**GBEP Appendix B – Summary (WR6) on Risk to Human Life Animal Life and the Food Supply Chain
Applicant Response to Roy Clegg Submission**

Written Representation (WR6) on Risk to Human Life, Animal Life, and the Food Supply Chain

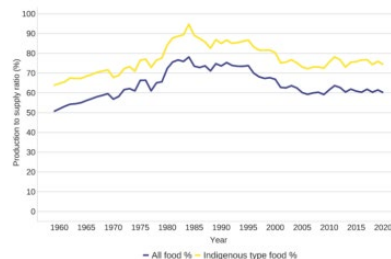
Does the Governments food strategy referred to as "broadly maintaining the current level of food we produce domestically" take account of the accelerating population growth including the influx of migrants?

The Government Food Strategy (2022) sets out objectives to "broadly maintain the current level of food we produce domestically". Overall, the UK produces about 60% by value of the food we eat, but that rises to about 74% of the food we can grow or rear in the UK, as shown below (graph taken from the UK Food Security Report 2021).

The reasons for the graph are many and varied. The UK remains largely self-sufficient in terms of cereals, meat, eggs, milk and many of the fruits and vegetables suited to our climate. Cottam Power Station as an alternative site The Cottam Power Station site is located partially in Flood Zone 2 and surrounded by Flood Zone 3 (see ES Figure 9.2 [AS-003/3.2]). The only areas that are not within the Flood Zone at the power station are the National Grid Substation, which is remaining in use, and two small areas between the cooling towers and the River Trent. The Gate Burton site is almost wholly in Flood Zone 1 so is sequentially preferred from a flood risk perspective.
